May 2008

Product Update

## New Magnum Revision 6.1

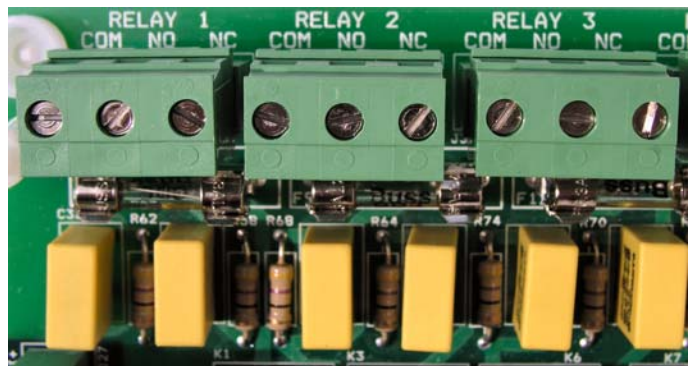
Micro Control Systems has introduced a new improved version of the MCS-MAGNUM-N board. In order to provide greater flexibility in relay output wiring and to hold down the rising cost of parts, we have changed all the removable connectors on the board to a newer euro style connector.

In addition, as shown below, there are now separate removable connector blocks for each of the ten relay outputs on the board, each providing a separate COM, NO and NC from its corresponding relay.

When using this new board to replace an older Magnum in the field, please remember that the wiring to the connectors will need to change. All other aspects of the board remain the same.
